## Planning Commission Staff Report

**Project Type:** Amended Site Development Section Plan

**Description:** **Chesterfield Village Mall (i-FLY)**: Amended Site Development Section Plan, Amended Landscape Plan, Amended Lighting Plan, Architectural Elevations and an Architect's Statement of Design for a 4.09 acre lot of land zoned "C8" Planned Commercial District located south of South Outer Forty Road west of its intersection with Chesterfield Center, more specifically addressed 595 Chesterfield Center.

Figure 4—Landscape Plan excerpt of reconfigured access points

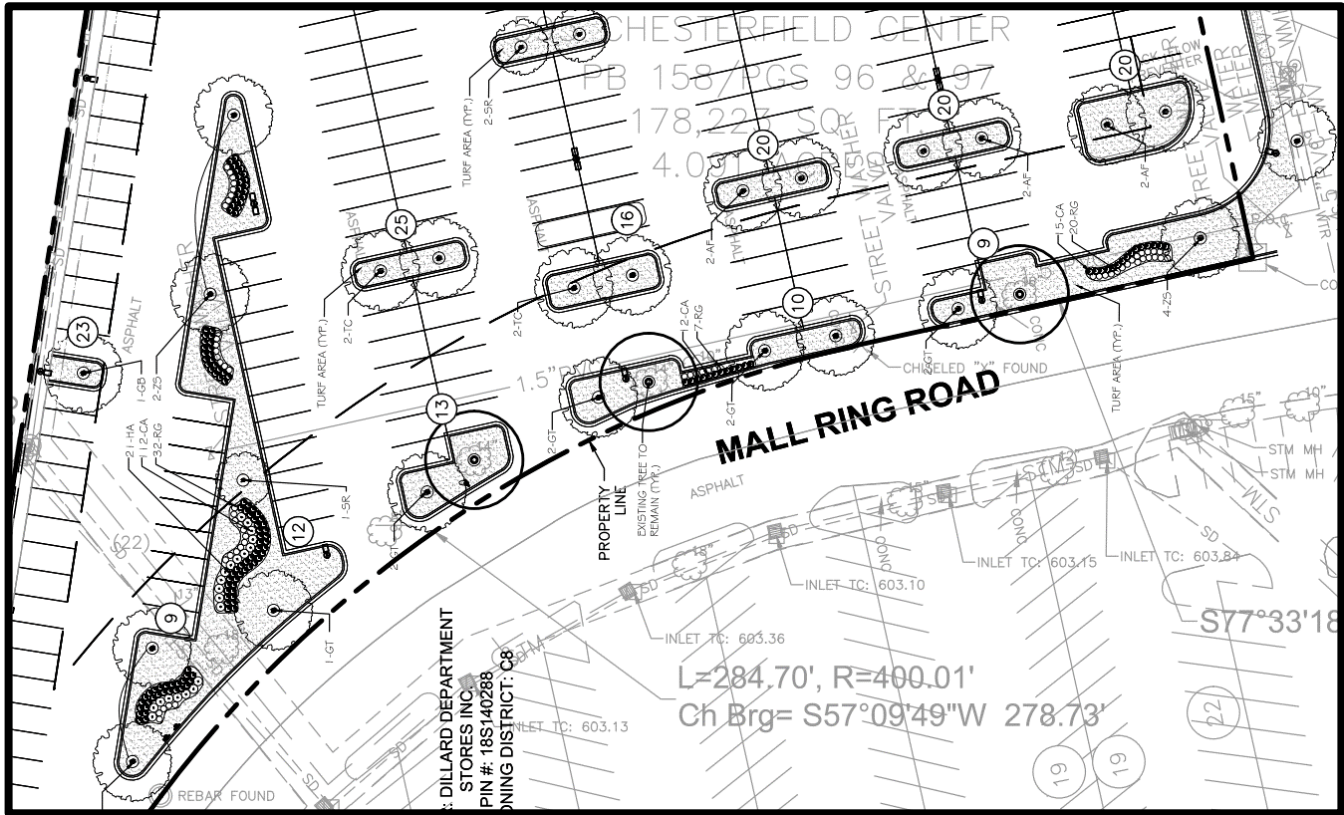
The site is accessed from Chesterfield Center Drive along the south property line, which is the internal, private mall ring road. Although numerous curb cuts exist along Chesterfield Center Drive and date back to the original development of the site, the applicant is proposing to eliminate three of the curb cuts. Large landscape islands will allow for improved site circulation while adding a significant amount of landscaping along the mall ring road frontage. This landscaping will also differentiate the subject site from the rest of the mall.

Figure 5—Night rendering of proposed accent lighting

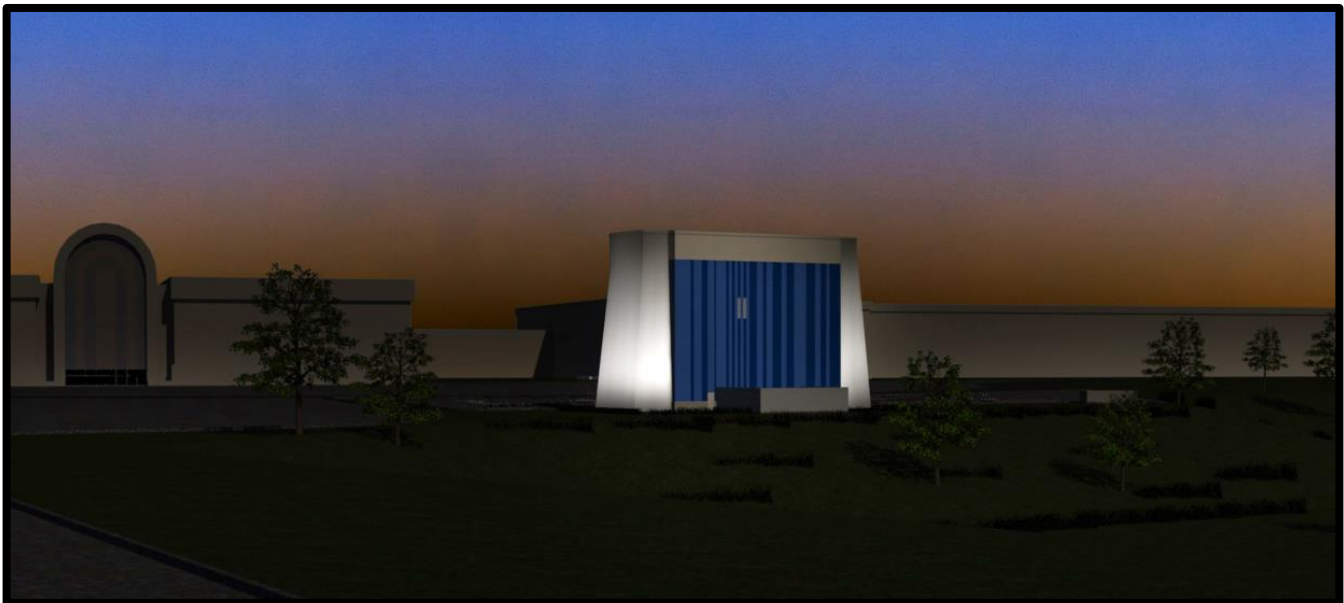
In addition to these, the applicant is proposing to utilize façade accent lighting on all elevations. This accent lighting consists of projections of a soft blue light on the side portions of the façade. Regarding such lighting, the Unified Development Code states the following:

**The ARB found that this lighting application was appropriate for this building design and location and that it was indeed architecturally integrated.** Further, the applicant has included night renderings and 3-D horizontal photometrics of the proposed lighting for the Planning Commission’s consideration. These supporting documents demonstrate adherence to the City’s Unified Development Code in that the light cast is limited to select portions of the building façade.

**LANDSCAPE PLAN**

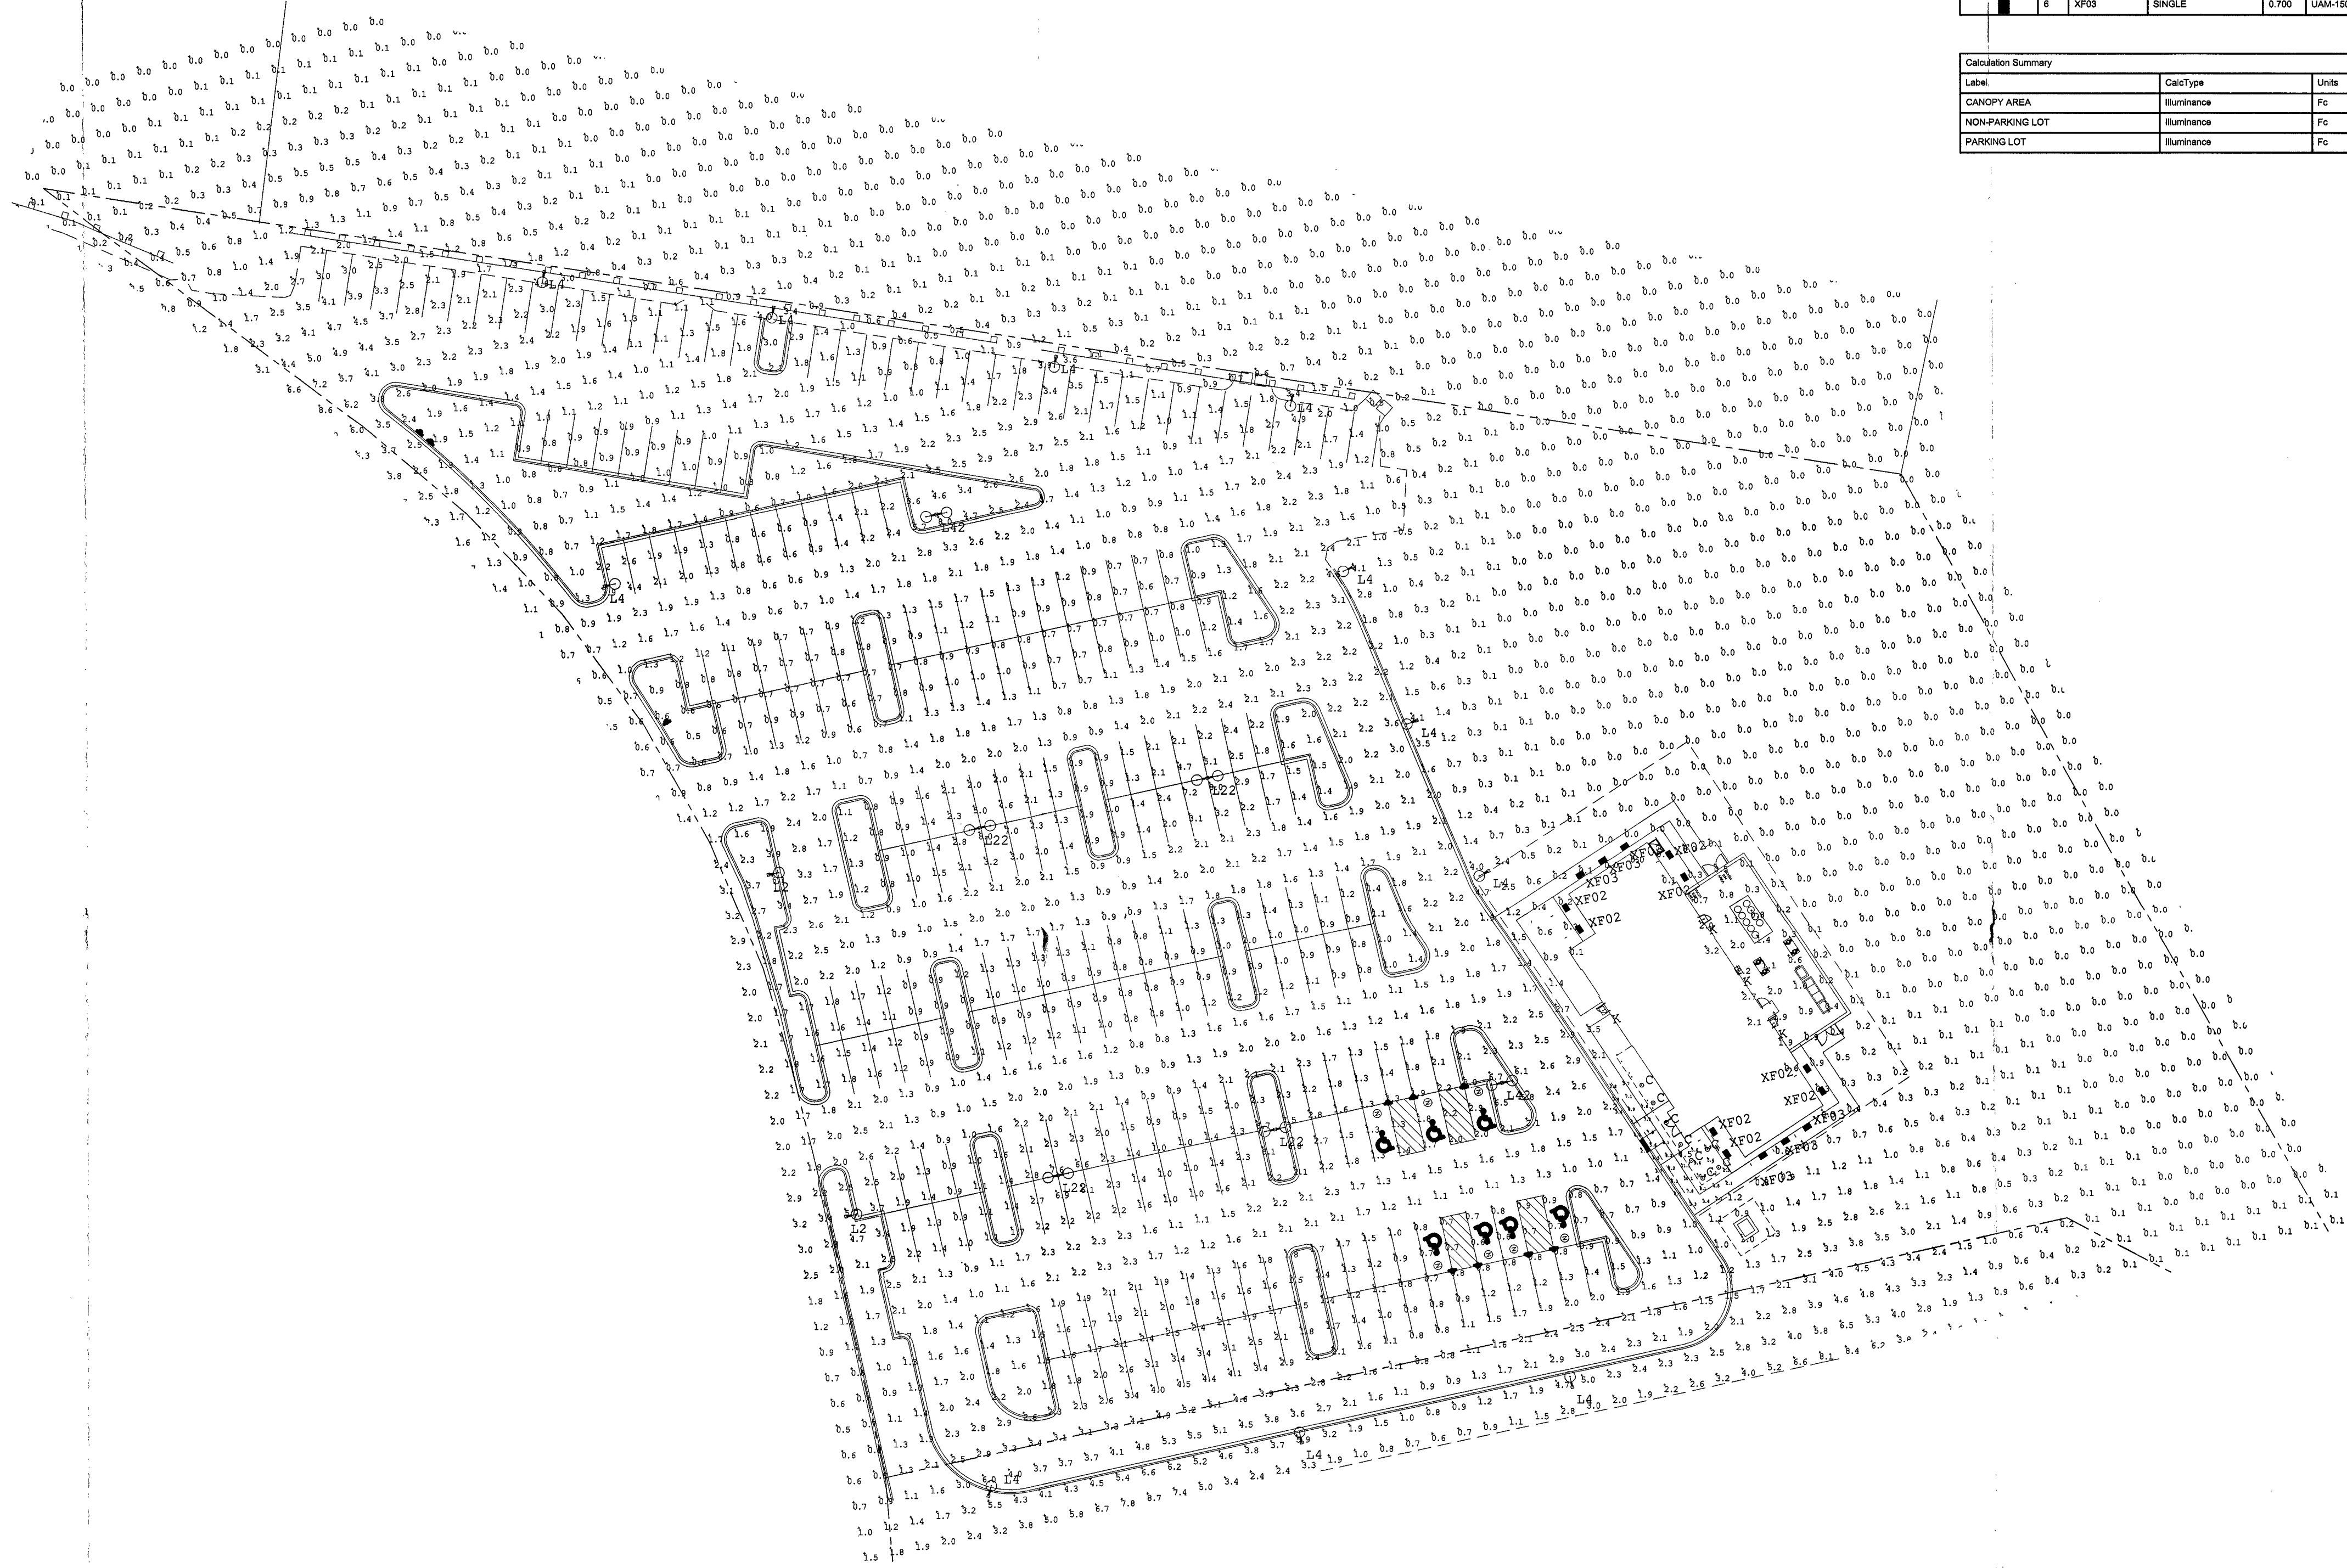
1. Integrate and soften the pedestrian areas with additional landscaping near the front entry.
2. Continue the landscape design proposed for the two islands adjacent to the front building entry across the entire first row of landscape islands.

In response to the ARB's recommendations, the Applicant has significantly increased the landscaped area along the front building elevation and the entire first row of landscape islands features the same planting design.
